# TOPOGRAPHIC – SITE PLAN MAP

## A TRACT OF LAND LOCATED IN THE SOUTHEAST QUARTER OF THE NORTHEAST QUARTER OF SECTION 12, TOWNSHIP 12 SOUTH, RANGE 66 WEST OF THE 6th P.M., EL PASO COUNTY, COLORADO

**SFD24616 ADU2425**

REVISED: 03/13/24  
TOPO -SP - A TRACT OF LAND IN THE SE1/4 NE1/4 OF SEC. 12 T12S, R66W OF THE 6th P.M., EL PASO COUNTY, COLORADO

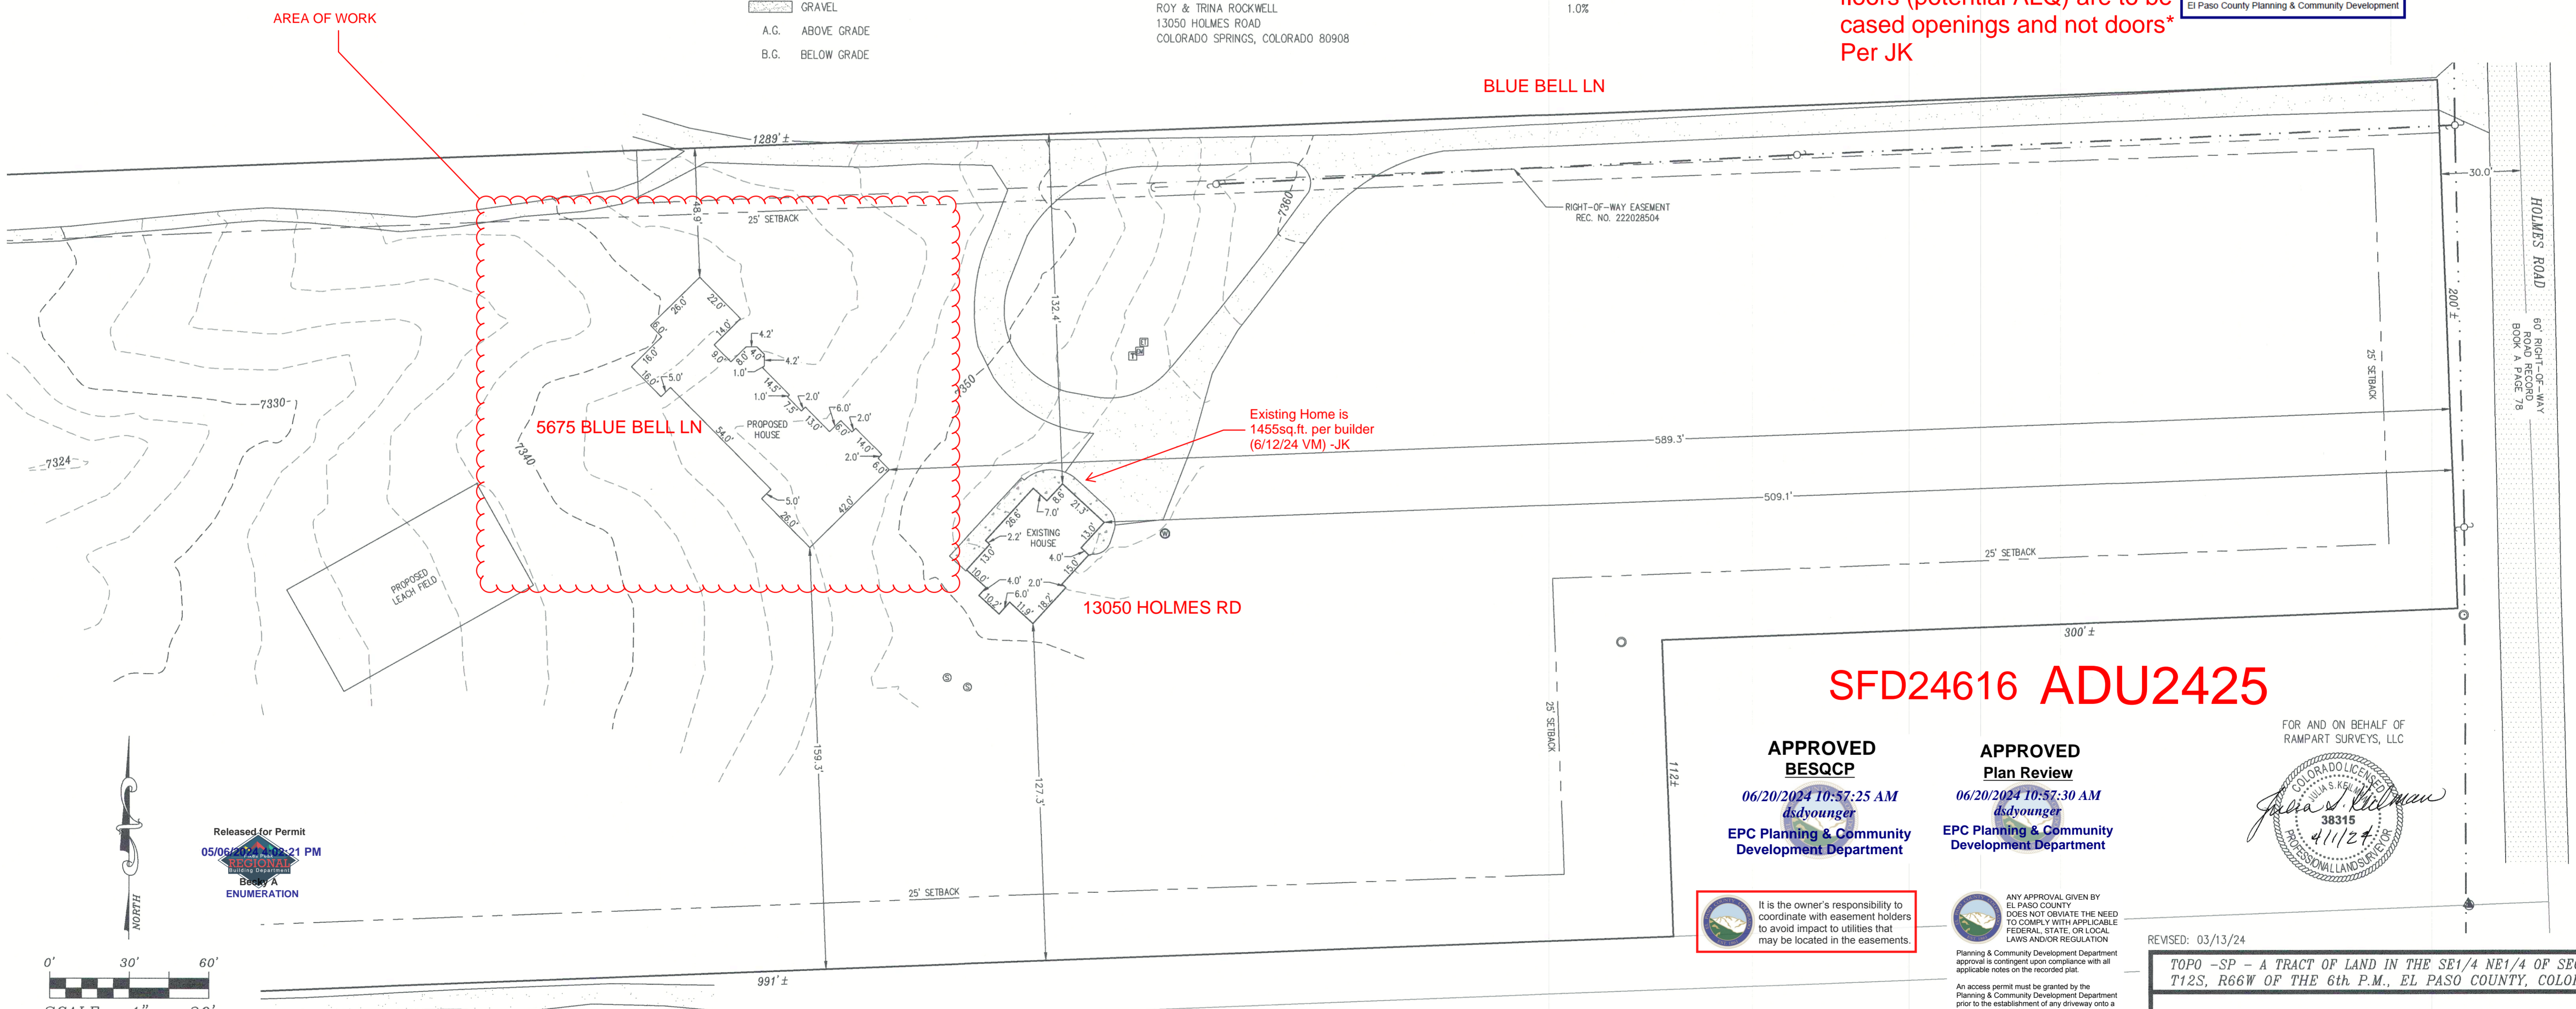
**\*Separation between the two floors (potential ALQ) are to be cased openings and not doors\*  
Per JK**
